Appendix A

Consultation Letters

Subject: Proposed Nuclear Plant in Victoria County, Texas
Request for Information on Threatened or Endangered Species

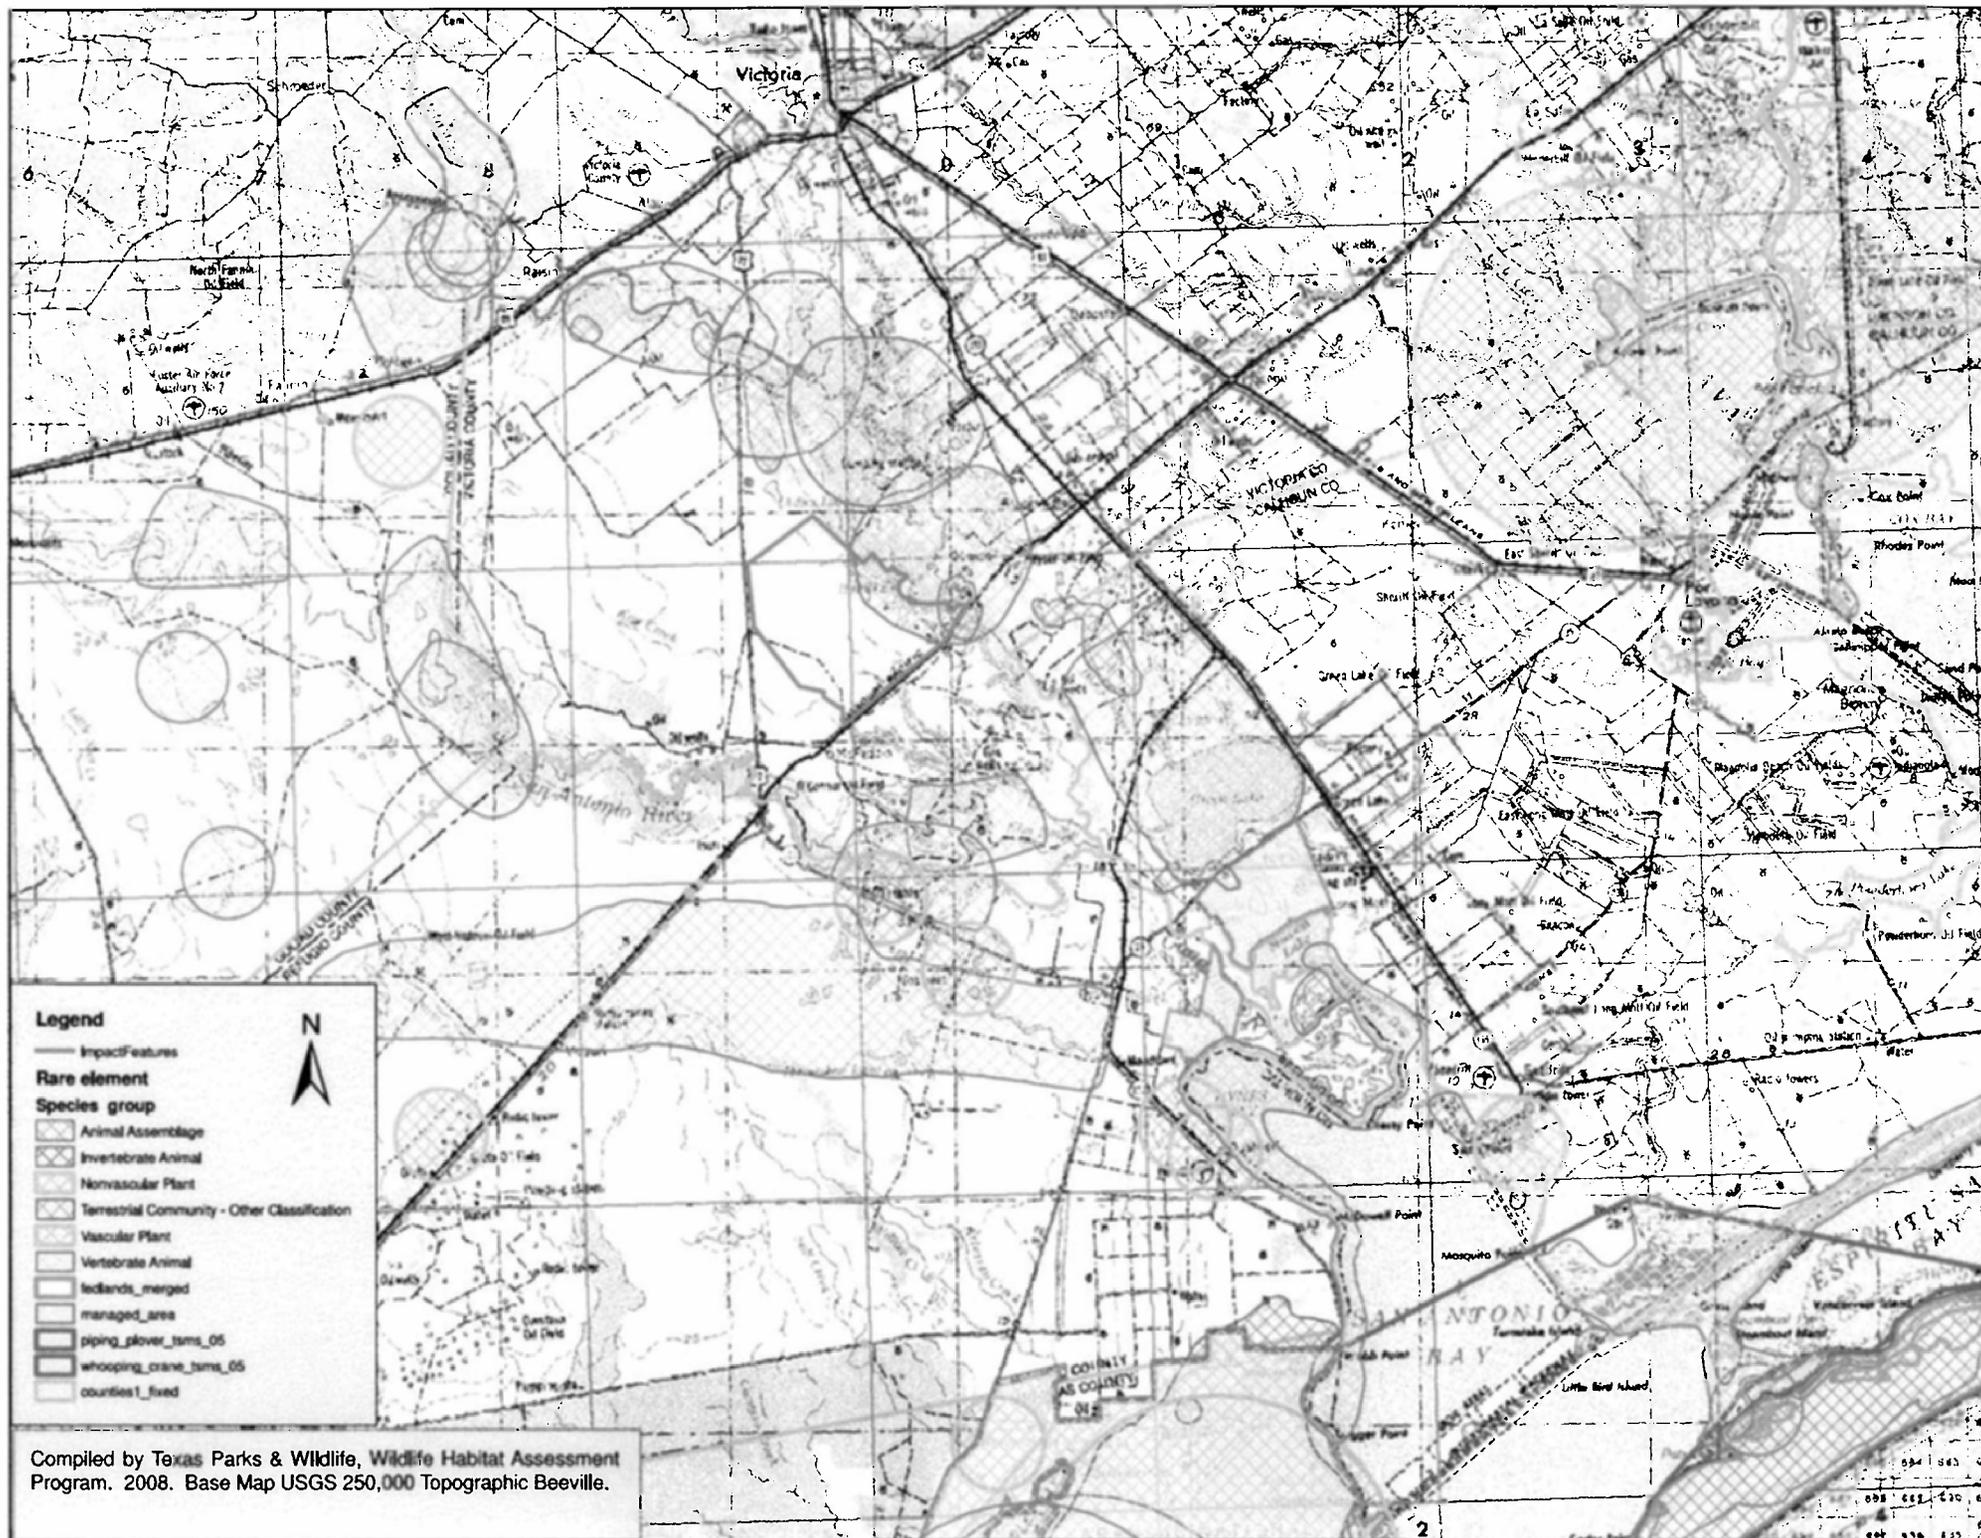
These managed lands are the nearest known sensitive managed areas. TPWD recommends Exelon conducted further research to identify other properties under conservation management in the area.
